Application for change or cancellation of resource consent condition (S.127)

Change of conditions (s.127)

Shift the boundaries of Lot 6 - 8, create a right of way ('I and 'J') for Lots 6 - 8, shift the indicative building platforms for Lots 6-9, amend the location of the drainage easements, change Lot 15 from a road to vest to a common access lot, and various other changes listed in the main report.

5. Reyburn and Bryant has prepared an amended scheme plan (S17346, Revision B). A copy of it is **enclosed**.

DATE	JANUARY 2026	SCALE	1:1250 @A3
DRAWING REF.	SHEET		REV
S17346	02 OF 04		B

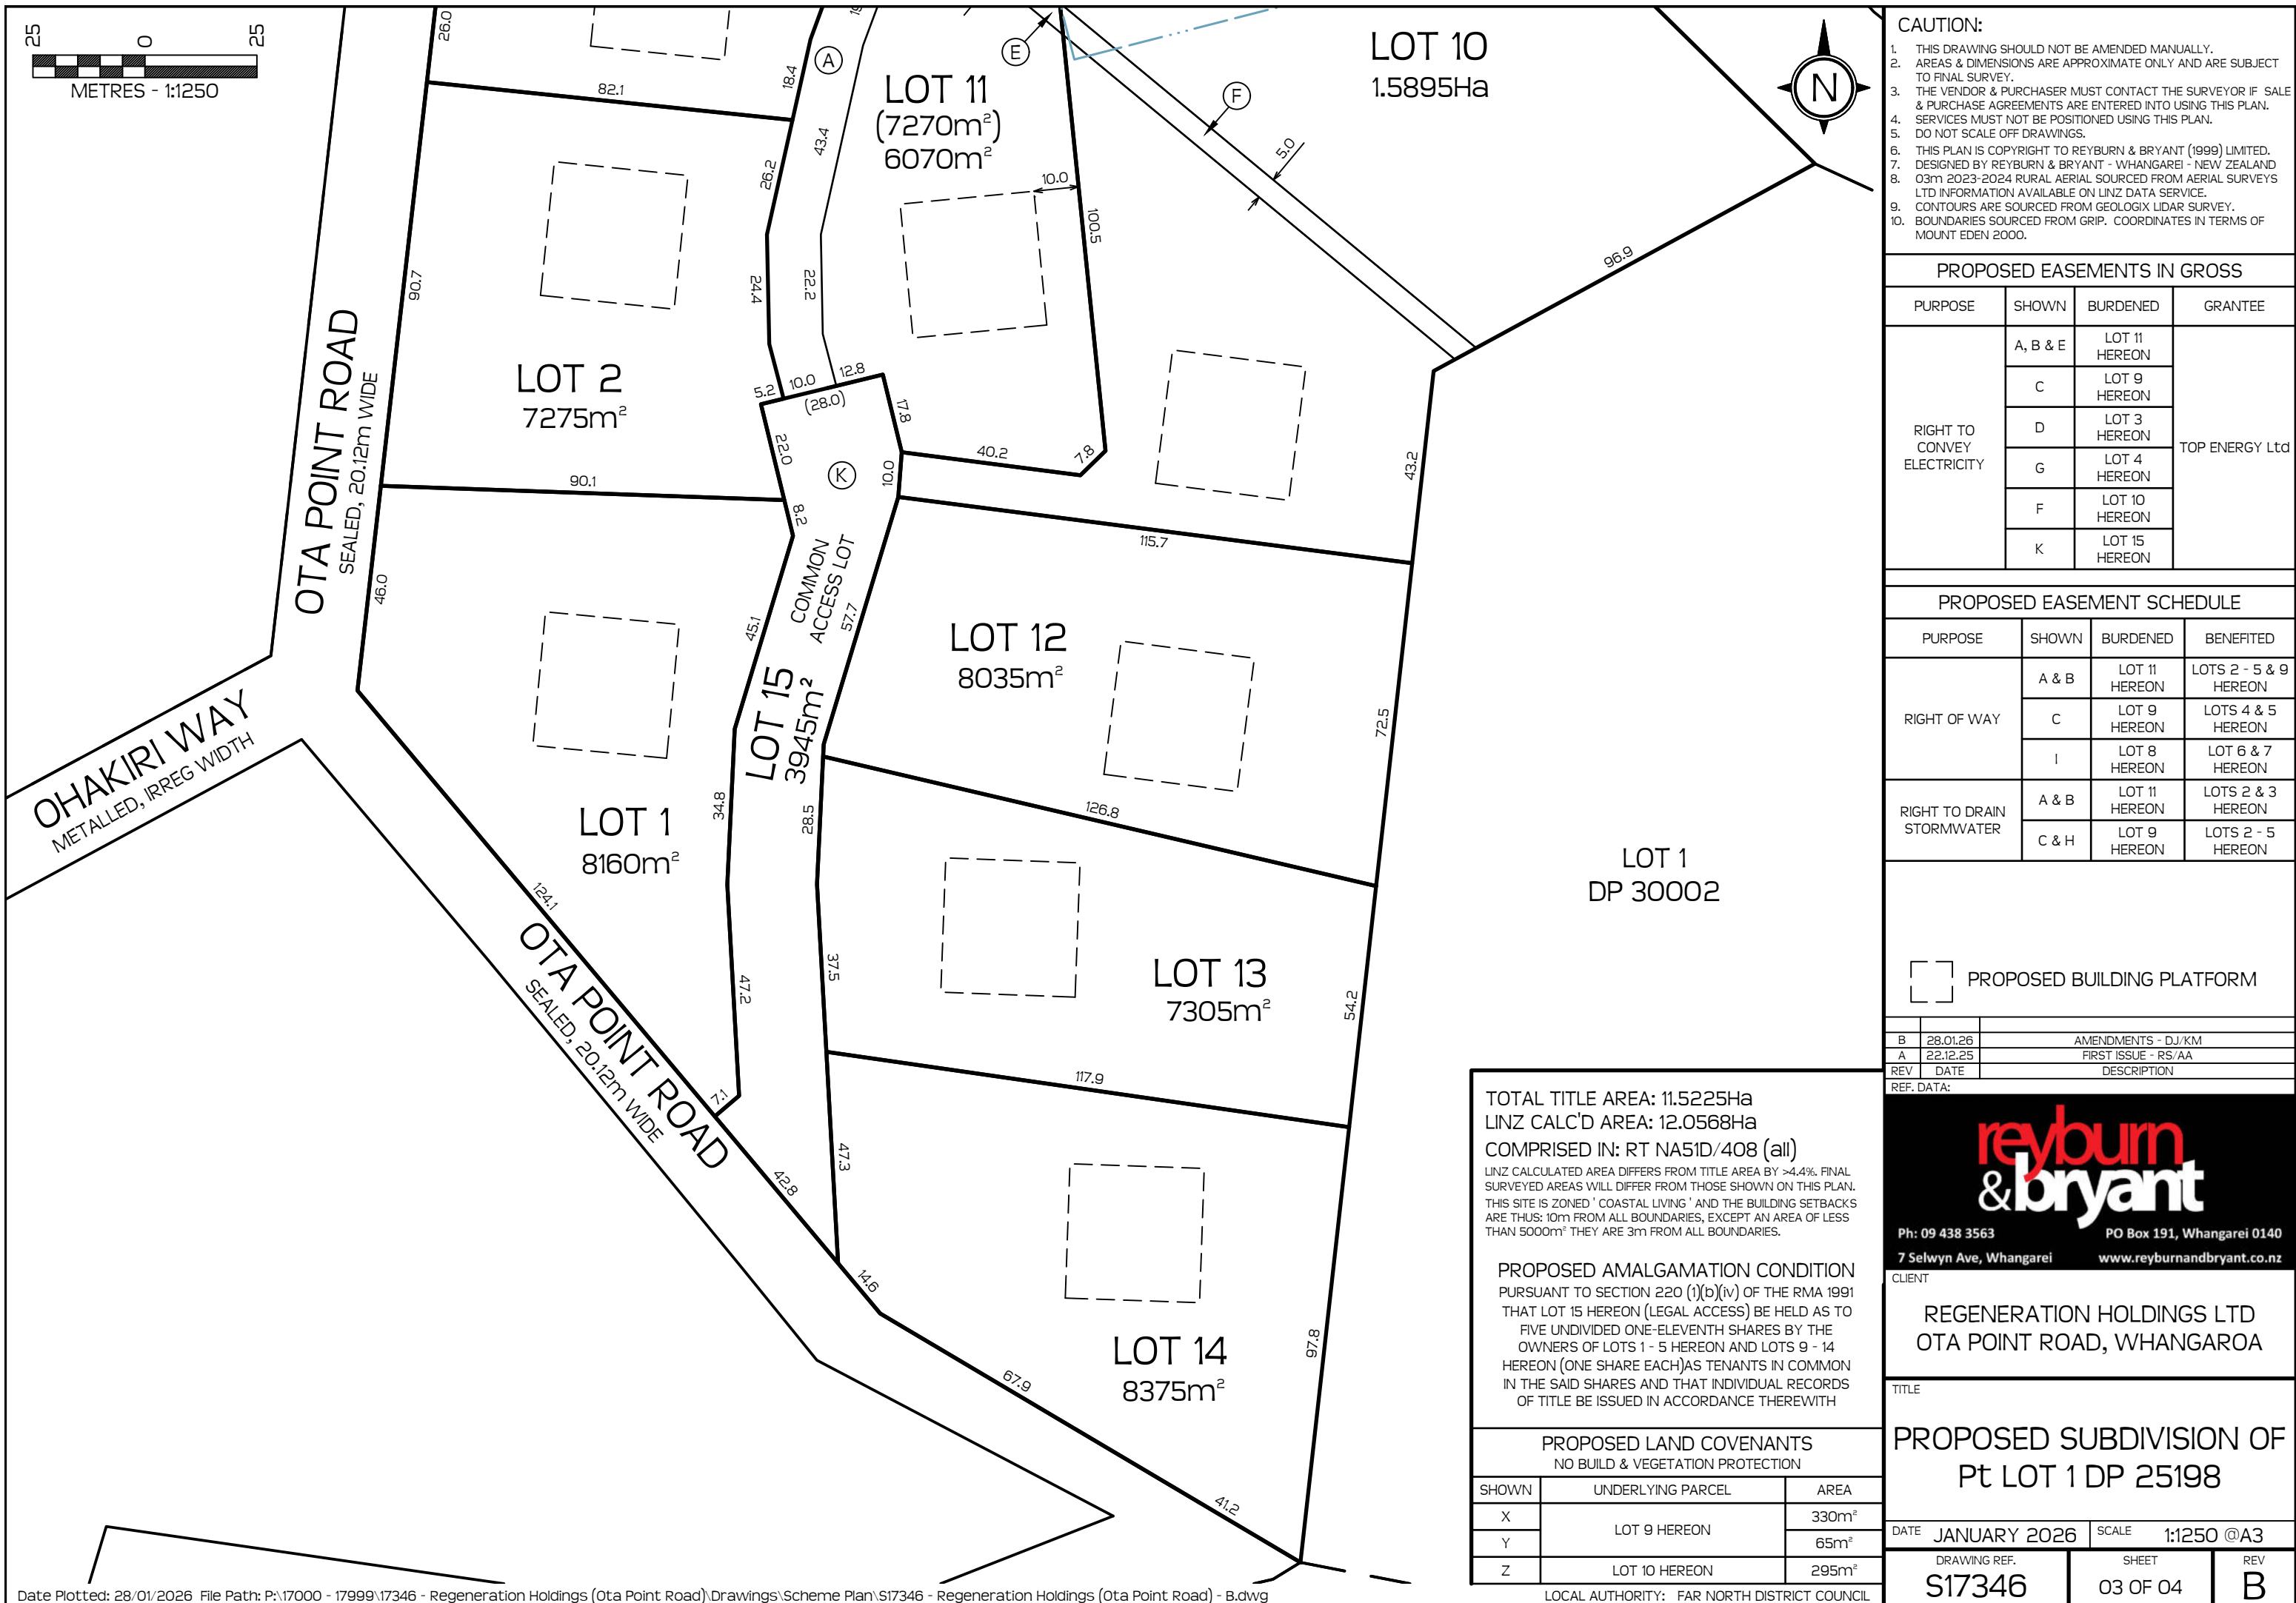
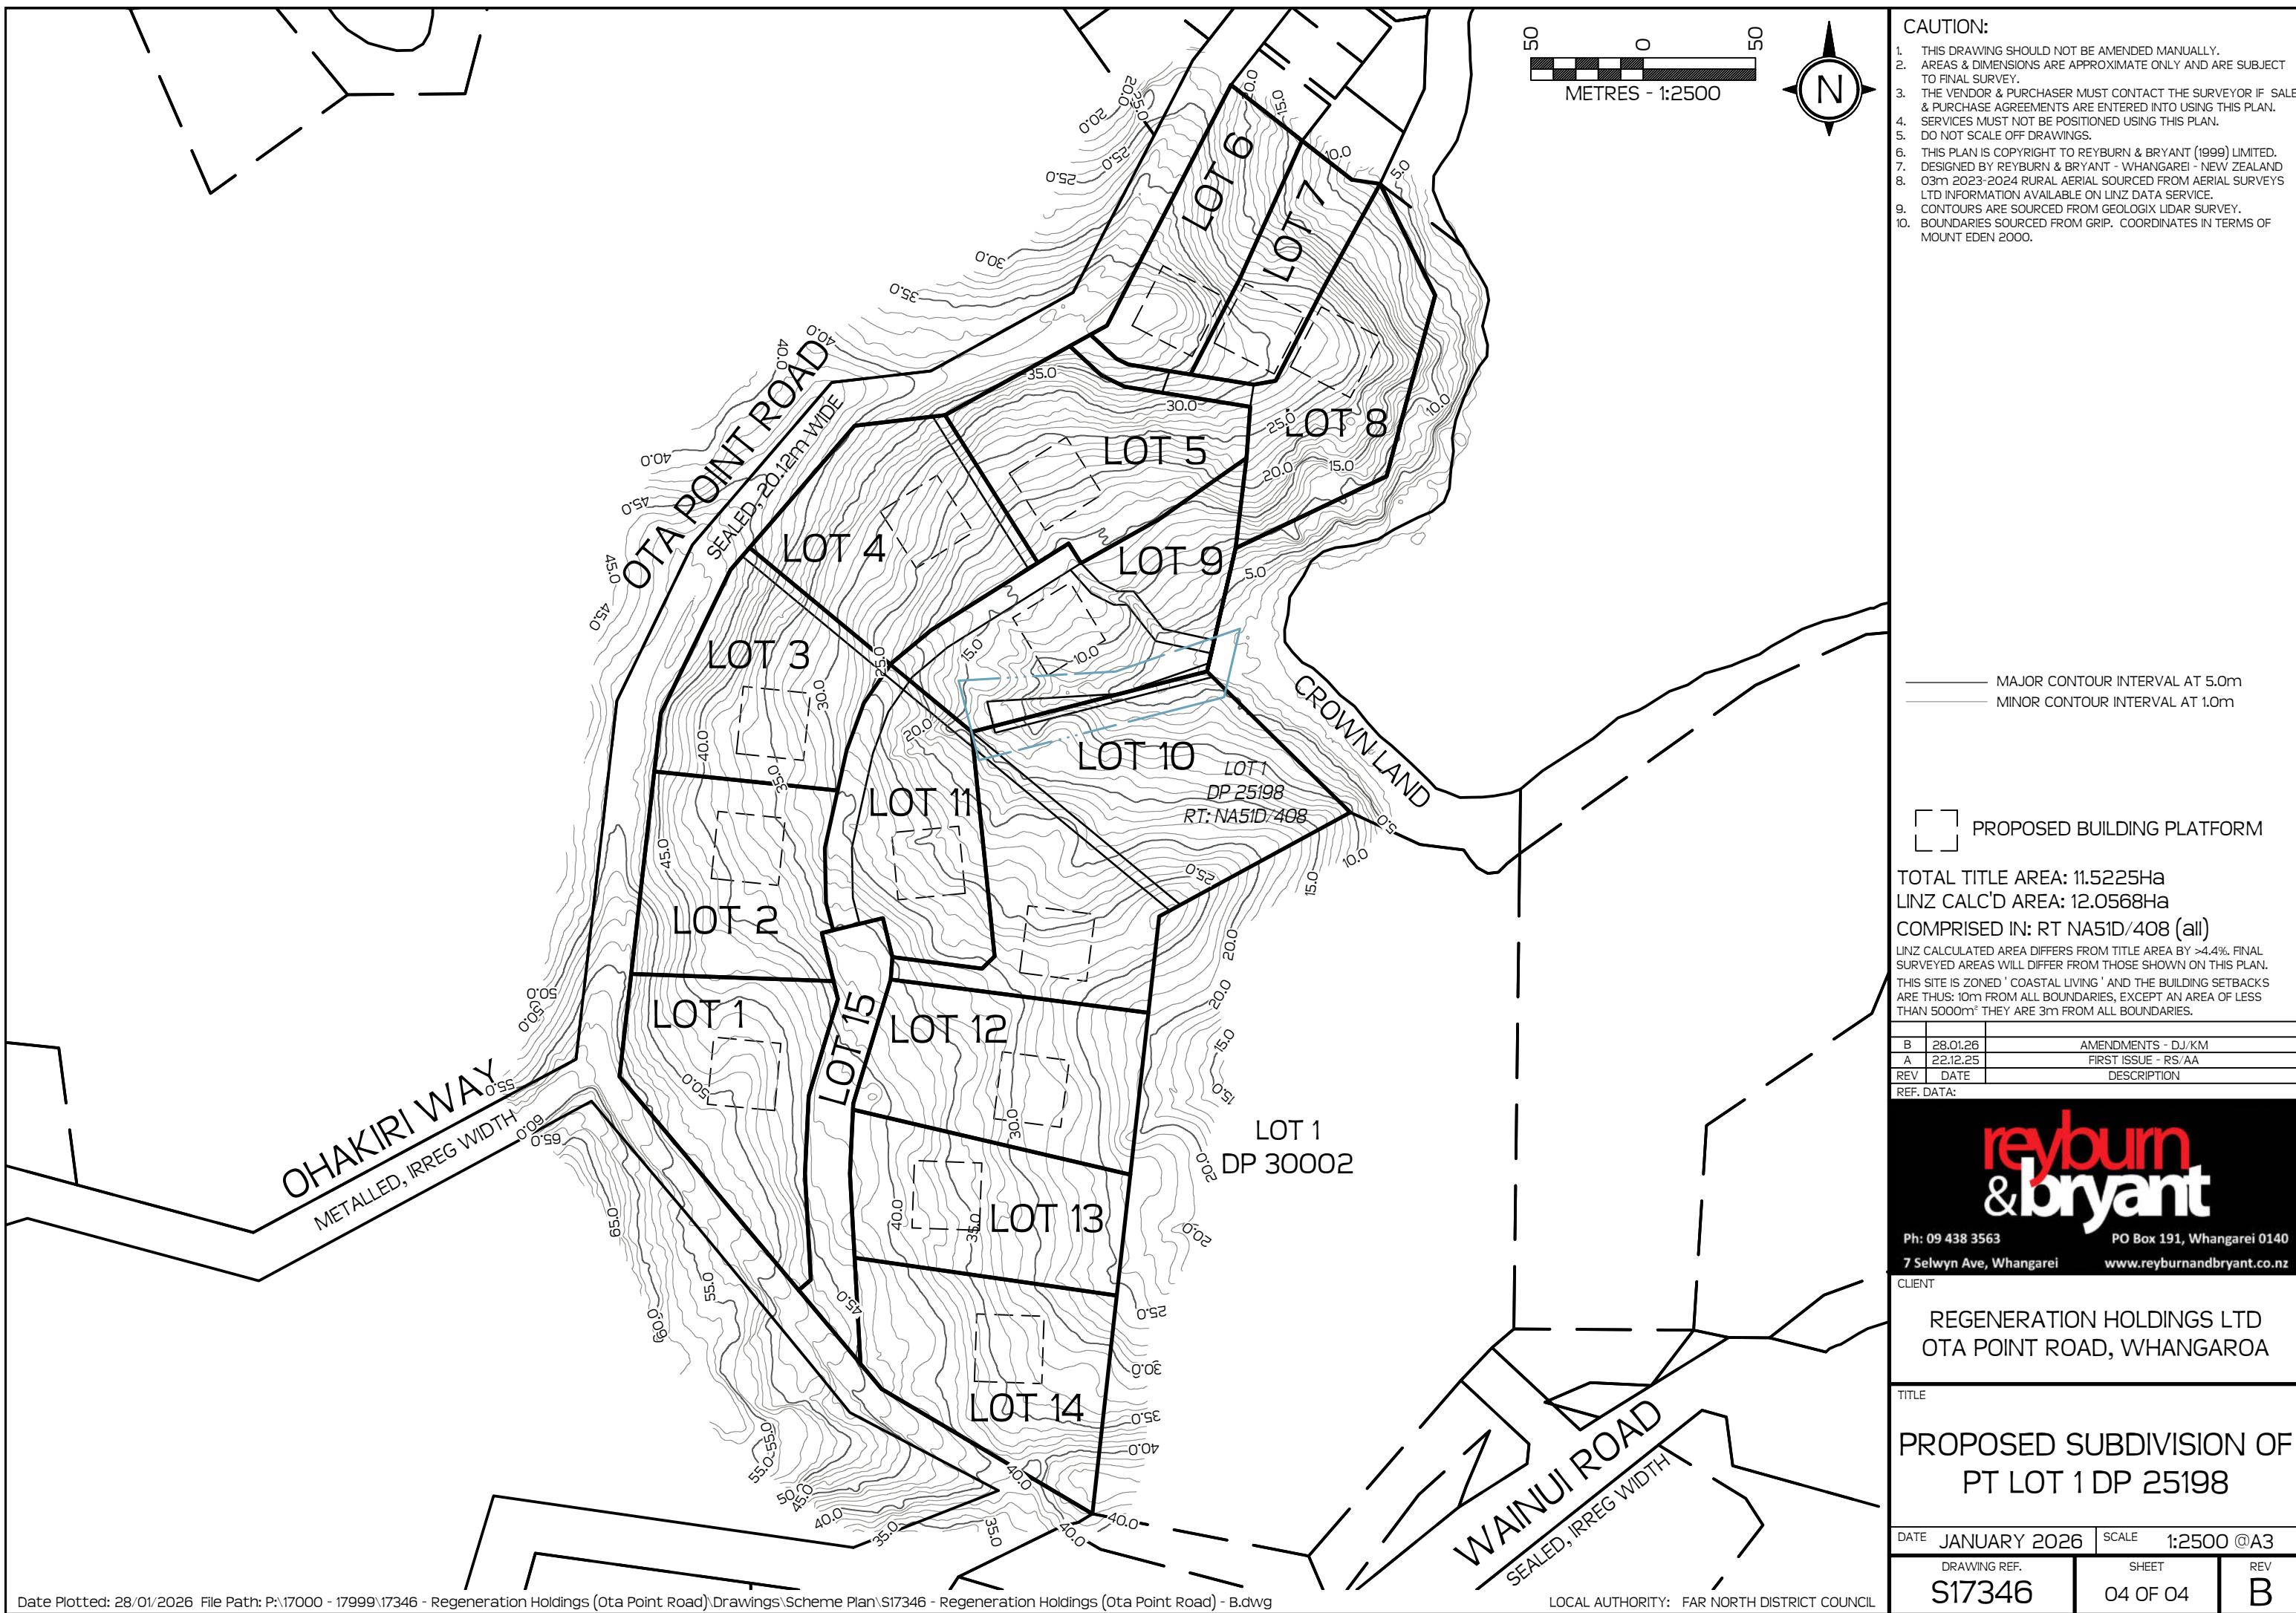
9. The shifted boundaries of Lots 6 – 8 facilitate new indicative building platforms. These are either in approximately the same location as the building platforms shown on the approved scheme plan (Lots 6 and 8) or will be further away from adjacent properties and encompassed by other indicative building platforms (Lot 5). The amended lot sizes³ remain in general accordance with the approved scheme plan as they differ by less than 10% from what was approved.⁴

12. Minor changes have been made to the boundaries and sizes of the other lots. Regardless, the lots are generally in the same location as the approved scheme plan, and the sizes remain in general accordance with what was originally approved.

15. It is proposed to change Lot 15 from a road to vest to a common access lot to reduce the formation standard and reduce the extent of earthworks required. Nonetheless, the new formation will still be appropriate for the eleven users.
